IEEE 802.3
Interpretations Report

July 24th, 2003
San Francisco, CA
David Law

Interpretation Number: 1-07/03 (Globally assigned multicast address)
Topic: Globally assigned multicast address bit order
Relevant Clause: Annex 31B
Classification:

Interpretation request 2-07/03

Figure 8—Universal address

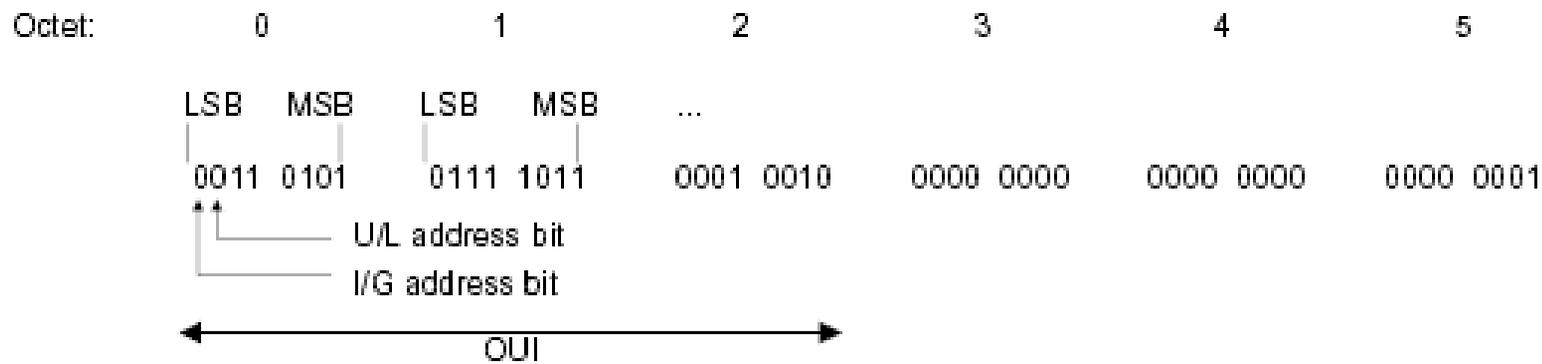
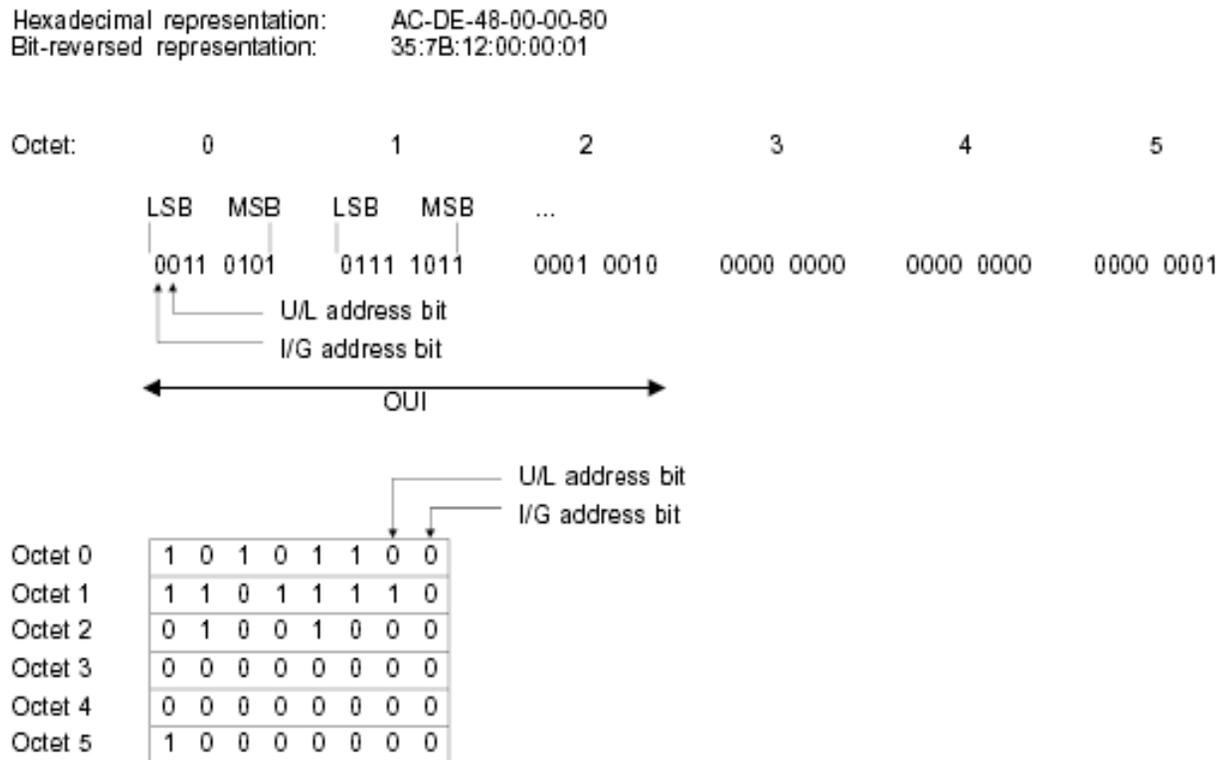
With reference to the globally assigned 48 bit multicast address

01-80-C2-00-00-01,

it's not clear which is the right order of nibble transmission on the MII interface.

There are 2 possible orders of transmission of the nibbles on the MII interface:

a) 1-0-0-0-0-0-2-C-0-8-1-0

In this case, I'm supposing the first octet of the address is the high order byte.

b) 1-0-0-8-2-C-0-0-0-0-1-0

In this case, I'm supposing the first octet of the address is the low order byte.

IEEE Std 802.3 clearly references the required information in subclause 3.2.3.1 'Address designation' which includes a footnote attached to the last paragraph which states 'For information on how to use MAC addresses, see IEEE Std 802-2001, Overview and Architecture.'

Referring to IEEE Std 802-2001, subclause 9.2, '48-bit universal MAC addresses', the third paragraph of subclause 9.2.1 'concept' states:

The standard representation of a 48-bit LAN MAC address is as a string of six octets, using the hexadecimal representation (3.1.8). In certain contexts associated with use of IEEE 802.5 frame formats, LAN MAC addresses may be represented using the alternative bit-reversed representation (3.1.2). See 9.5 for further specification relating to use of the bit-reversed representation.

NOTE - The upper, bit-stream representation of the universal address in Figure 8 shows the LSB of each octet first; this corresponds to the data-communications convention for representing bit-serial transmission in left-to-right order, applied to the model for transmission of LAN MAC address fields (see 6.2.3). See also 9.5 for further discussion of bit-ordering issues. The lower, octet-sequence representation shows the bits within each octet in the usual order for binary numerals; the order of octet transmission is from the top downward.

This provides a clear mapping from the address written out in the standard and its transmission order.

Due to the infrequency with which the hexadecimal address format appears within 802.3 it may not be obvious that Clause 3 contains the needed reference. Due to this we will submit a maintenance request that will propose to add a cross reference back to subclause 3.2.3.1 from Annex 31B.

Figure 48-2—Functional block diagram

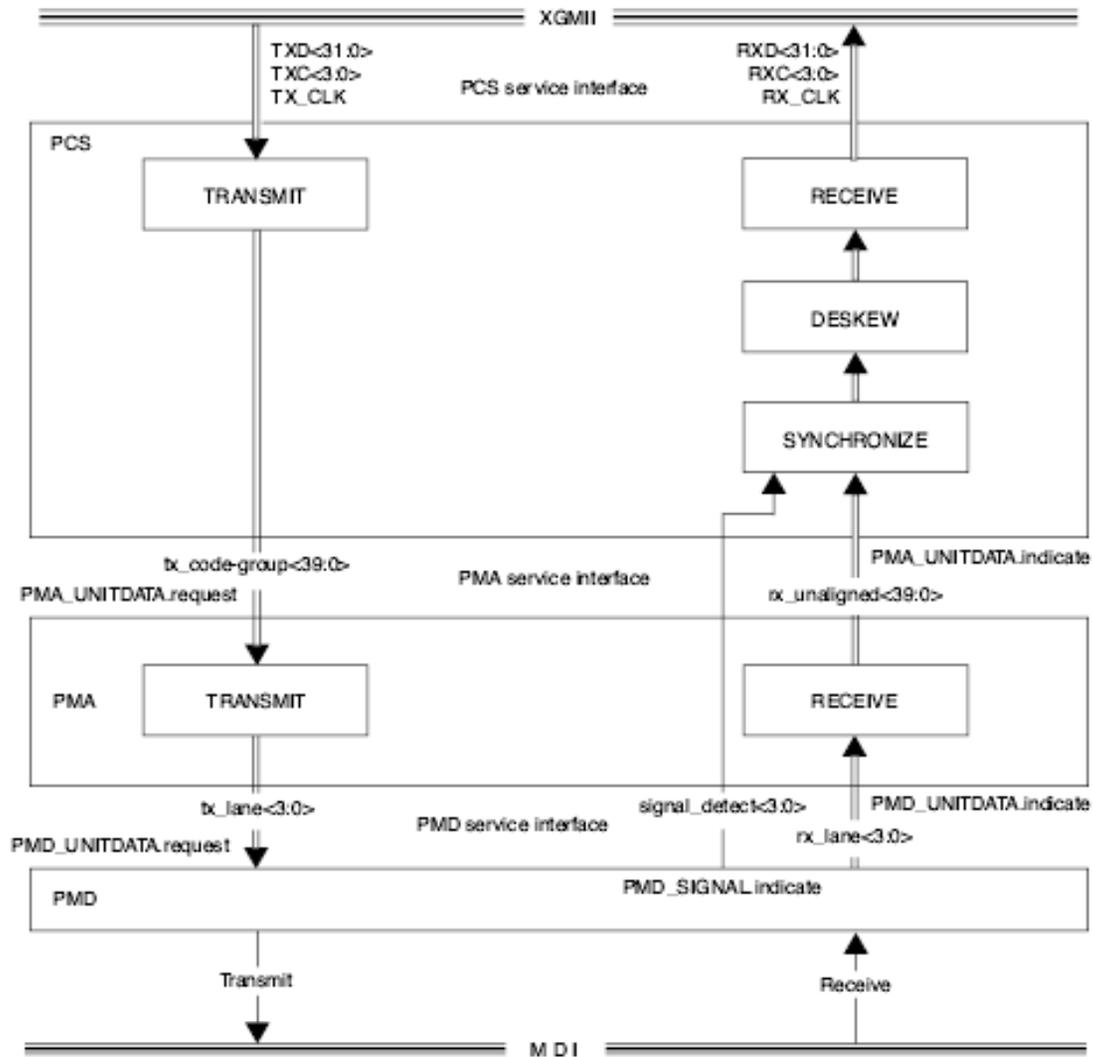
It appears that there seems to be a contradiction in the control bit description when using the terms “receive” and “transmit” in clause 45 and clause 48.

In general, clause 48 refers to “transmit” as the direction in which data is sent to XAUI, while “receive” is the direction in which incoming data from XAUI is accepted, synchronized and deskewed. This is clearly stated in Figure 48-2. Additionally, Table 48-7 assigns the state “align_status” to the Management Register Bit “4.8.10 Receive local fault”.

In subclause 45.2.4.8.1, the definition of register bit “4.24.12 PHY XGXS lane alignment status” describes this bit as “PHY XGXS transmit lane alignment status”. This is a contradiction to the definition given in clause 48. It should better read “PHY XGXS receive lane alignment status”, because lane alignment is only done in receive direction and there is no data alignment in transmit direction. Consequently, bit 4.1.2 should be renamed because it is the latched status of bit 4.24.12.

Clause 48 specifies the 10GBASE-X PMA and PCS and does not specify XAUI which, while built upon the 10GBASE-X PMA and PCS specification, is specified in Clause 47. In particular Figure 48-2 illustrates a 10GBASE-X PHY as stated in subclause 48.1.7, and not XAUI.

Within the Clause 47 XAUI specification, subclause 47.2.1 states 'Since the PHY XGXS operates with the XGMII below the XAUI, the transmit requirements of 48.2 and 48.3 apply to the PHY XGXS receive requirements and the receive requirements apply to the PHY XGXS transmit functionality.' As an example of this the PHY XGXS transmit function includes a lane alignment and therefore a PHY XGXS transmit lane alignment status bit is provided in subclause 45.2.4.8.1.

Based on this reversal defined in subclause 47.2.1 the bit definitions related to the PHY XGXS in Clause 45 are correct.
